**FIRE SERVICE AGENCY
 REVIEW**

Address of Site NW Skyline Blvd. East of NW Cornelius Pass Road, Address Pending.
 Map & Tax Lot: 2N1W31C-2500 'R' number R244442
 Description of Proposed Use: Storage of Roadway Deicing Fluid and Sand Loader
 Total Square Footage of Building (including roof projections, eaves & attached structures): 4,452 sf
 Applicant Name: Michael Schweizer Phone: 541-602-5705
 Mailing Address: 885 Airport Road SE, Building X
 City: Salem State: OR Zip Code: 97301 Email: mike.schweizer@odaot.

DATE	REVISION	BY	DESIGNED: MIKE SCHWEIZER	PRELIMINARY	OREGON DEPARTMENT OF TRANSPORTATION FACILITIES SERVICES BRANCH	FACILITY NO. F	SKYLINE STOCKPILE SITE PLAN MULTNOMAH COUNTY, OR SITE PLAN	SHEET 1 OF 4
			DRAFTED: FRANCO			DATE 09/23/20		DRAWING FS-1
			CHECKED:			CALC. BOOK		
			REVIEWED:

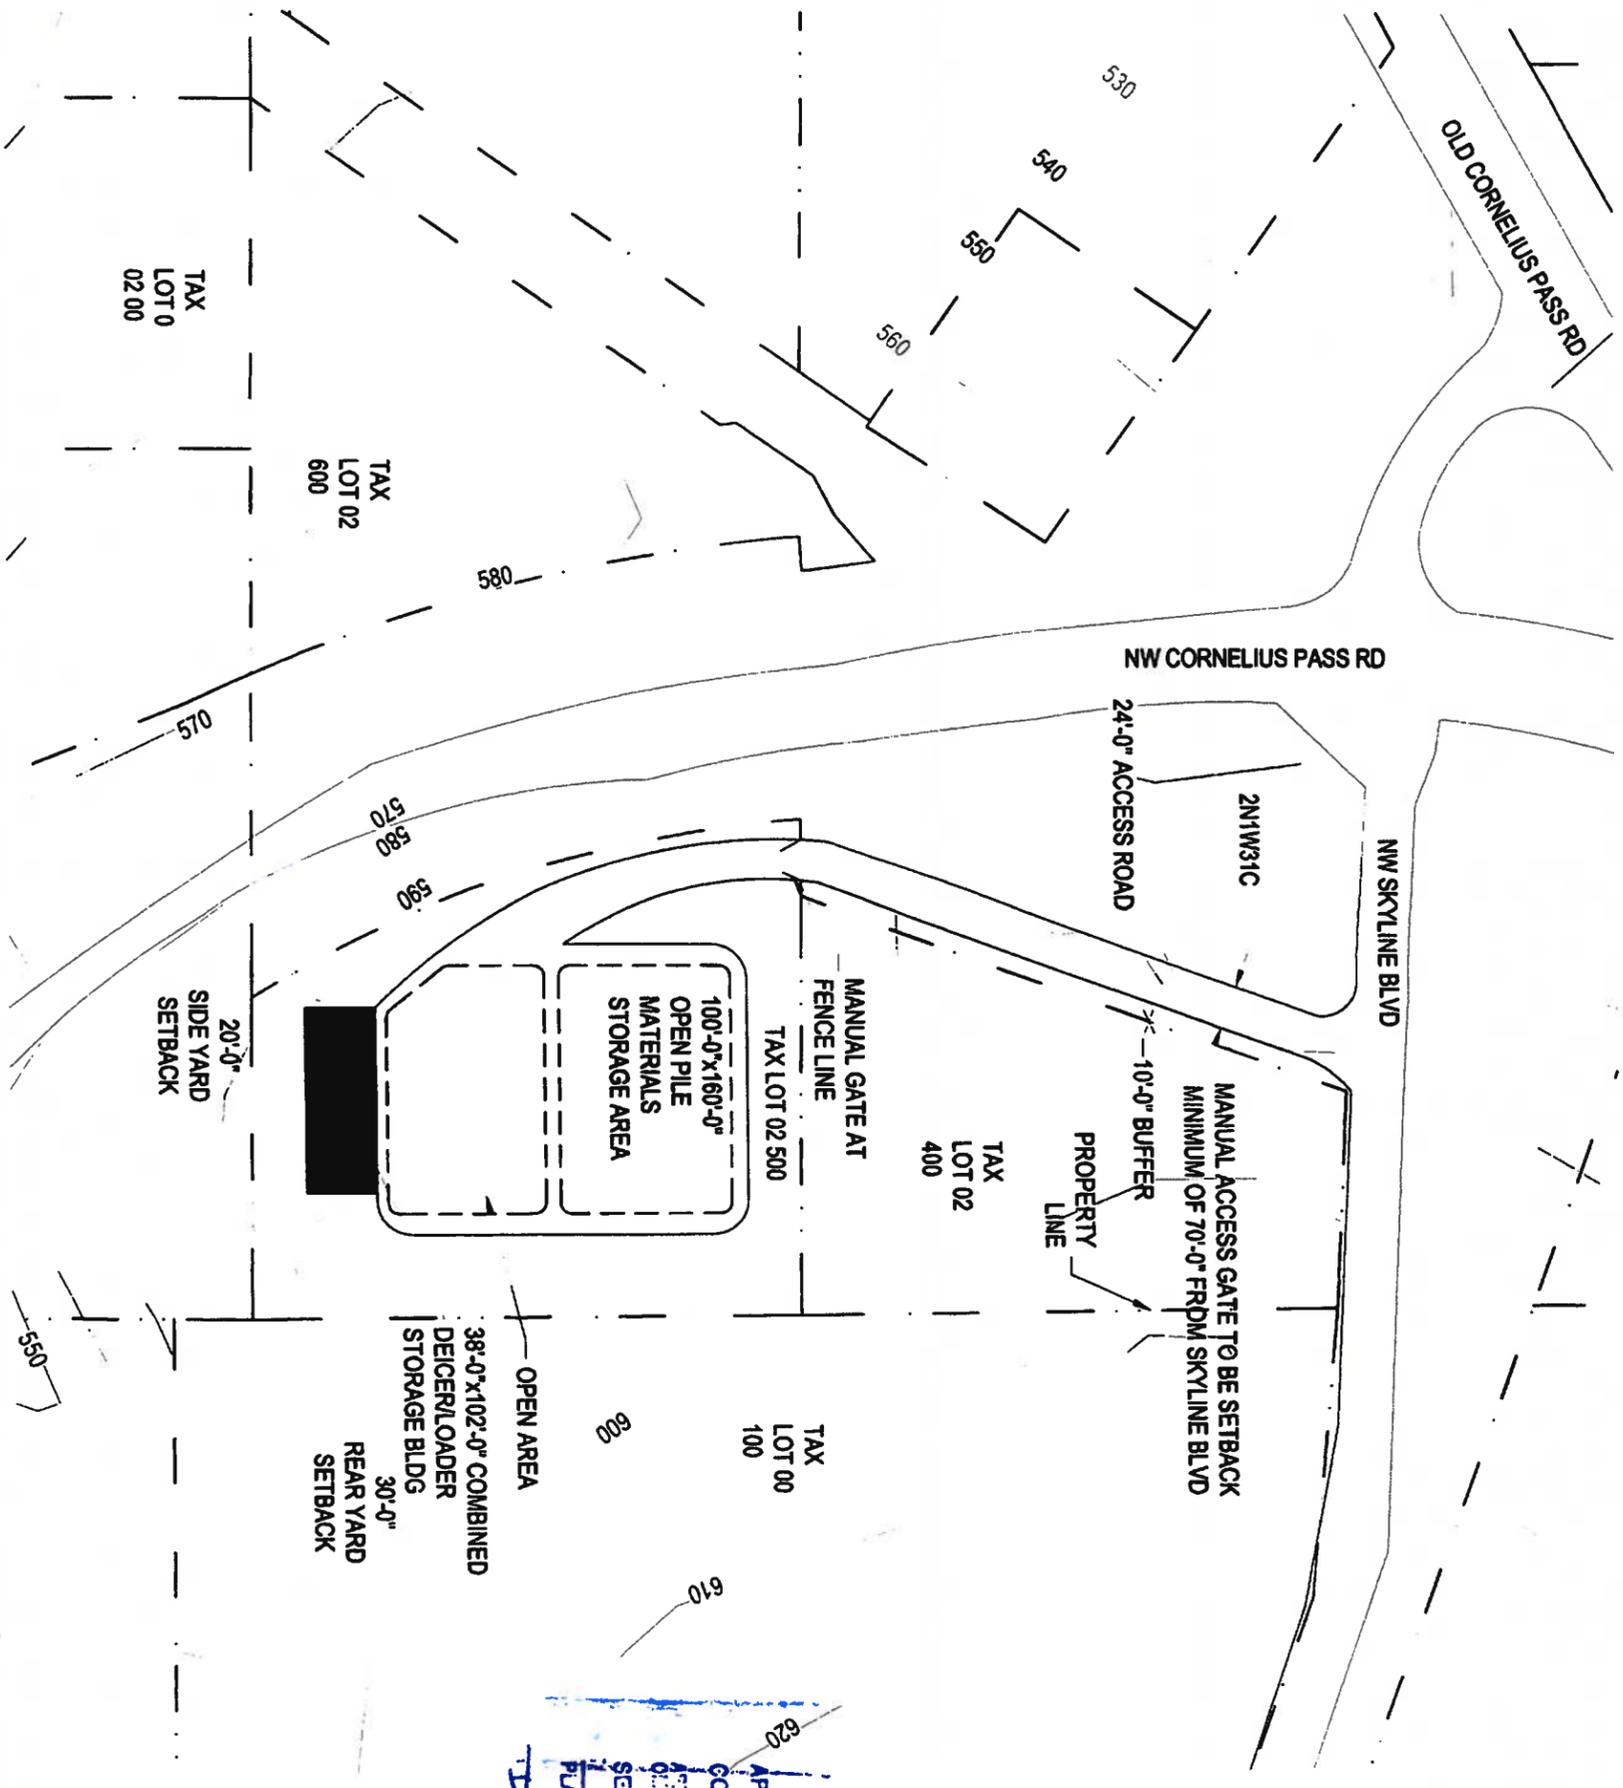
Post a physical address near the intersection of the private driveway and public way visible from both approaches of NW Skyline Blvd. OFC, 505. Private driveway to be an all-weather surface capable of supporting 75K GVW and 12.5K wheel load. OFC, 503.2.3

Square footage of the structure is below the threshold for an on-site firefighting water supply. Water to be supplied by fire water tender vehicles-operations.
